Evaluation of a Buffer Zone at an Ilmenite Mine operated by Rio Tinto on the Shores of Lakes Besaroy and Ambavarano, Madagascar

**Steven H. Emerman,
Malach Consulting**

Report to Andrew Lees Trust, submitted May 27, 2018

Evaluation of a Buffer Zone at an Ilmenite Mine operated by Rio Tinto on the Shores of Lakes Besaroy and Ambavarano, Madagascar

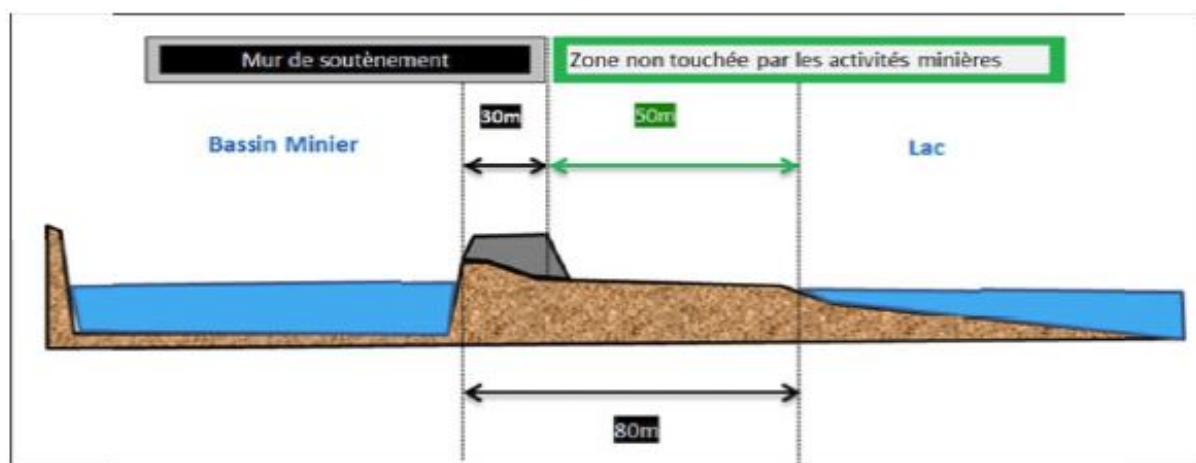
The “lake protection berm” is 4 meters high and 30 meters wide (QIT Madagascar Minerals, 2015, see Fig. 3) and was designed with a factor of safety of 1.3 for a 50-year flood (Rio Tinto, 2017). In addition, the water level in the mining basin is maintained 1-2 meters below the surface of the natural water bodies and 3 meters below the elevation of the adjacent

topography (QIT Madagascar Minerals, 2015). According to QIT Madagascar Minerals (2015), the water level in the mining basin could not be maintained at any lower level without significant influx of groundwater into the mining basin. No document from Rio Tinto has provided any further information regarding the design or construction of the “berm.”

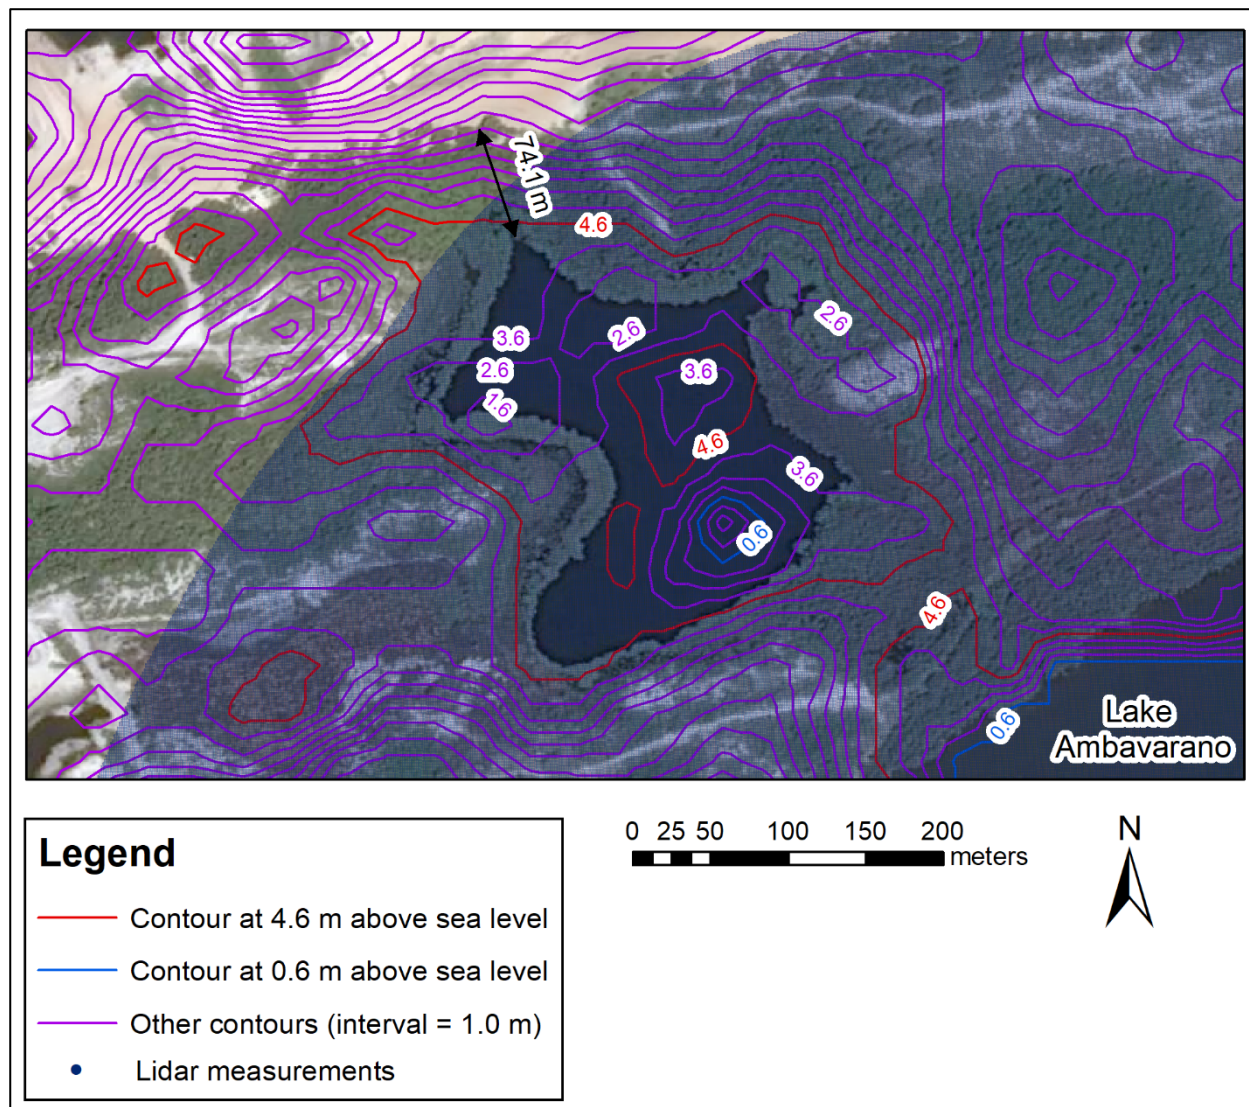
The nearly 8.5 million Lidar measurements covered nearly 9.5 km², and were assembled into 10,543 30-m pixels (see Fig. 10A). Although these measurements were used to determine the elevation of Lakes Besaroy and Ambavarano (Rio Tinto, 2017), no data were collected over Lake Besaroy (see Figs. 10A and 10B). The spatial extent of the Lidar measurements is just barely adequate to cover the encroachment in Rectangle B (equivalent to Site 2 of Ozius Spatial (2018); see Fig. 10B). On the other hand, the spatial extent of the Lidar measurements is insufficient to document the encroachment at Rectangle C (see Fig. 10C), and this location was not examined by Ozius Spatial (2018).

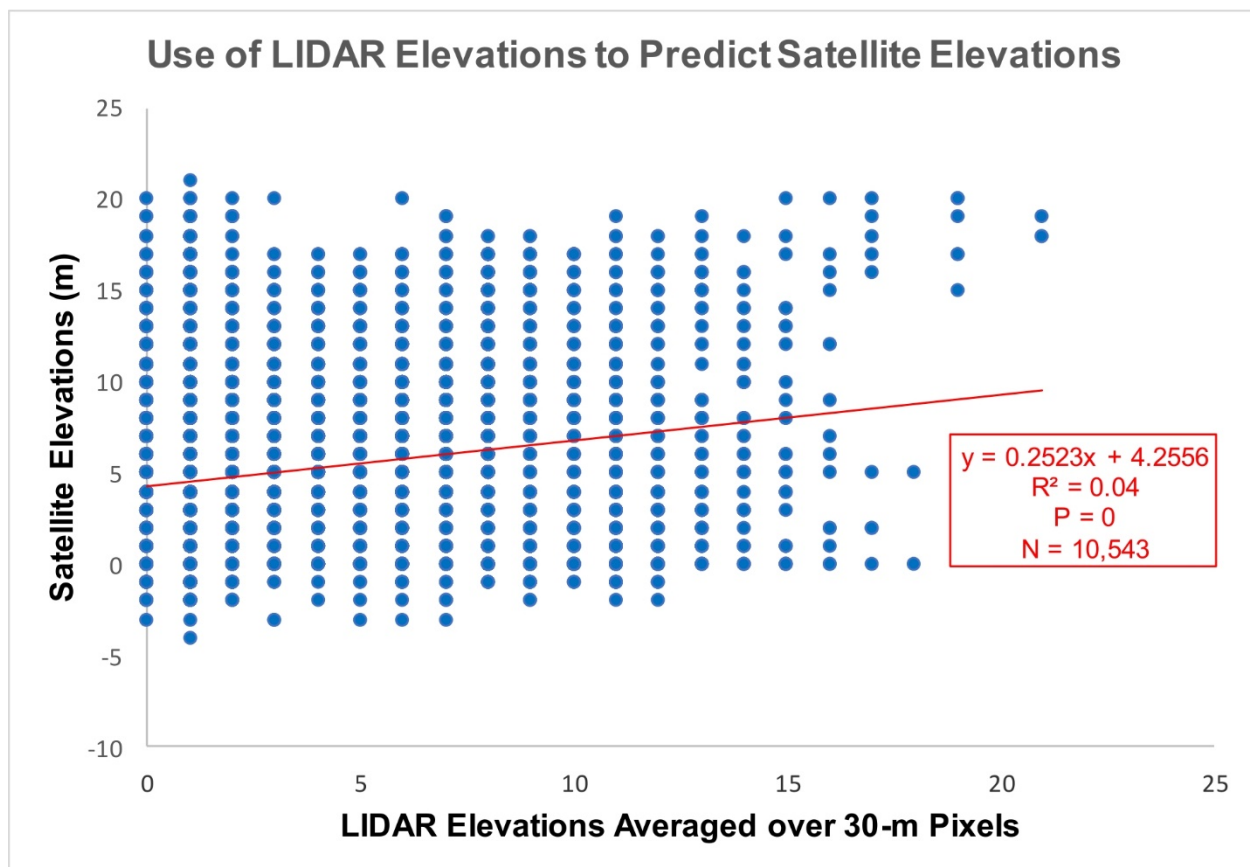
The best-fit regression line that predicted the satellite elevations from the Lidar elevations had an intercept of 4.26 meters with a 95% confidence interval of 4.14-4.37 meters (see Fig. 11). This vertical offset is consistent with the determination by Rio Tinto (2017) that the estuaries have an elevation of 0.6 meters above sea level and the determination by this study that the estuaries have an elevation of 4.6 meters above sea level, equivalent to a 4-m vertical offset. (Recall that the resolution of the satellite data is only 1 meter.) The source of the vertical offset cannot be determined without knowing how the Lidar data were calibrated. It is possible that the Lidar data were never calibrated because, as mentioned above, only relative elevations are needed to document compliance with a buffer zone.

The source of the considerable scatter in the plot of satellite elevation vs. Lidar elevation is more difficult to explain (see Fig. 11). The correlation is certainly statistically significant ($P = 0$), although the variation in the Lidar data explains only 4% of the variation in the satellite data. It is not possible to explore this question any further without knowing the methodology behind the Lidar data. The most important pieces of missing information are the locations of the control points, how the control points were used to process the data, and how the position of the aircraft was determined.
